Technical Journal

Seat hard to push back, second row seat (7 seater)

REF NO: TJ32025.5.0	ISSUING DEPARTMENT: Technical Service	CAR MARKET: United States and Canada	
PARTNER: 3 US 7510 Volvo Car USA		ISSUE DATE: 2019-09-26	STATUS DATE: 2019-10-10
FUNC GROUP: 8531	FUNC DESC: Rear seat, complete	Page 1 of 6

2:nd row in 7-seater: Hard to fold back backrest

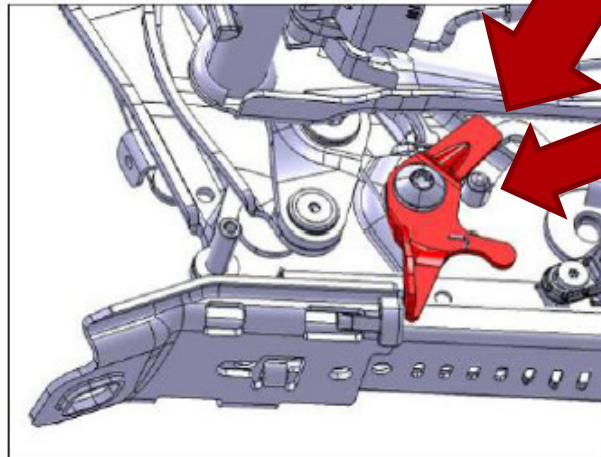
- Outer seat in 2:nd row is hard to move back after entrance to 3:rd row.
- Backrest folds back too early (before seat is slided back).

Stopping edge of rebound bracket wear against the stop screw. This wear prevents it from releasing.

- Replace the rebound bracket.
- New concept "knee lever" to be introduced.

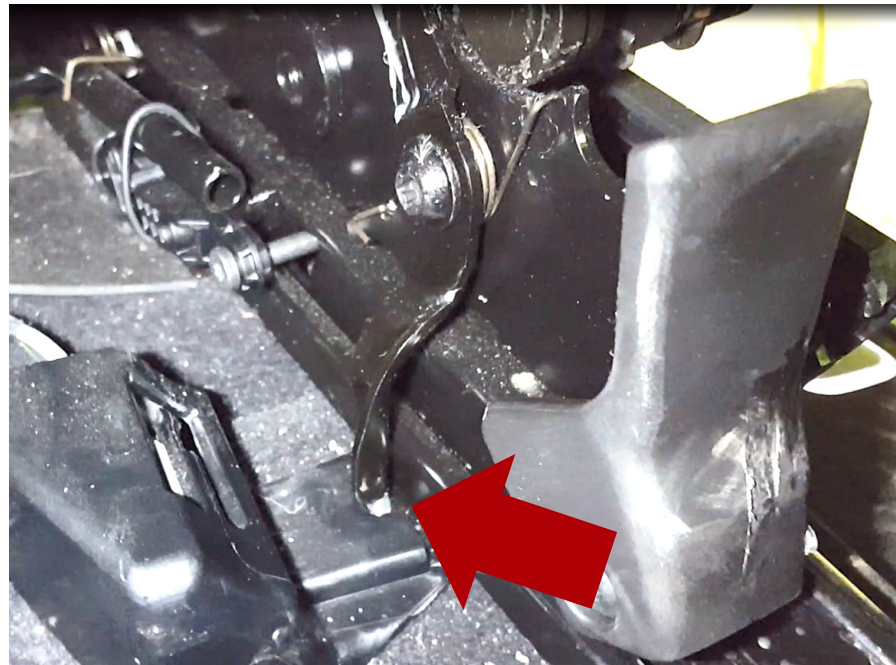
Outer seat in 2:nd row is hard to move back after entrance to 3:rd row.

Lower part of rebound bracket sticks on screw head.

- Grind down the screw head.
- New concept with lower screw head.

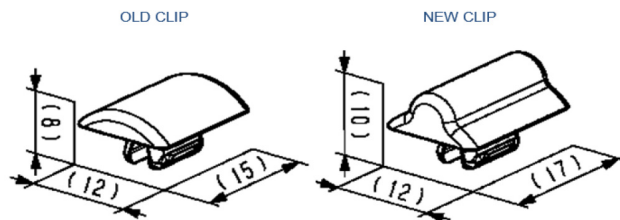
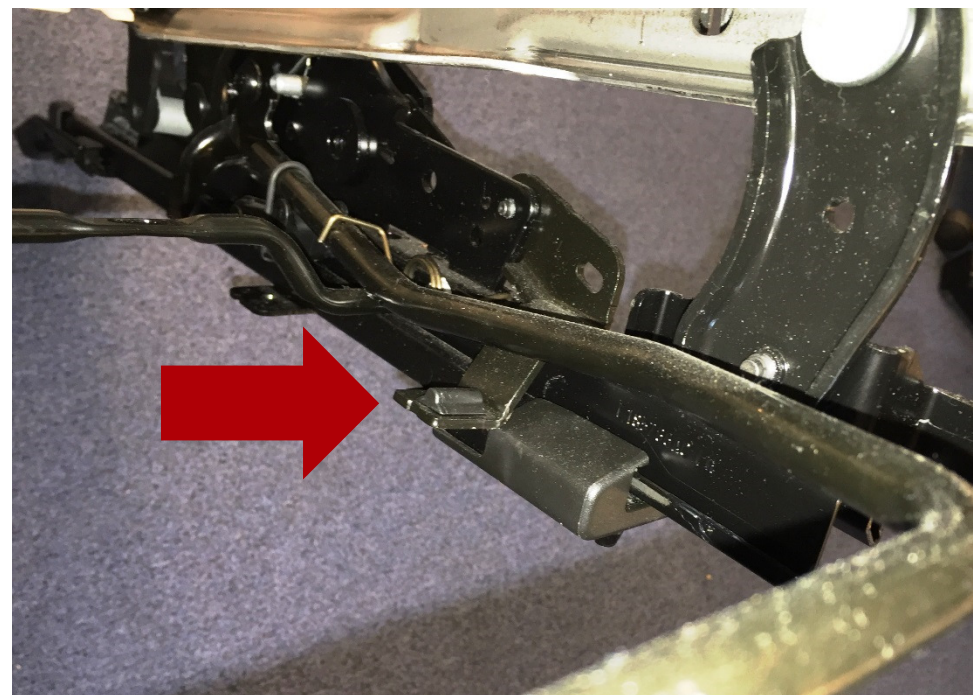
Outer seat in 2:nd row is hard to move or makes rattling noise over the rails.

Plastic stoppers for adjustment lever forward/backward too low.

Replace stoppers to new, higher model.
No p/n change.

Issue: 2:nd Row outer seat, 7 seater

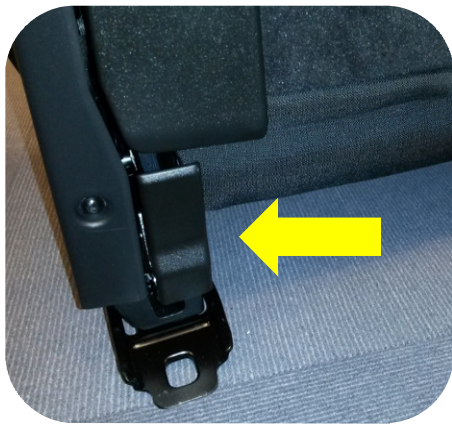
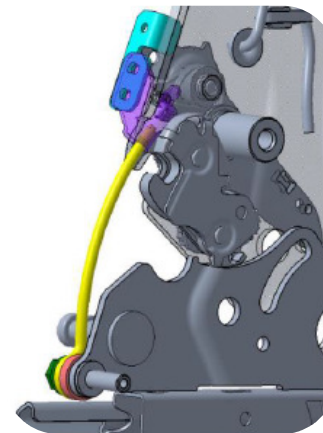
Gap closer can get stuck and damaged when back rest is folded back.
To avoid on current cars: Always start from normal position when seat are supposed to be flat folded. (Do not start from easy entry position.)

Solution step 1 Current Gap closer will be redesigned.

Solution step 2 New concept under development.
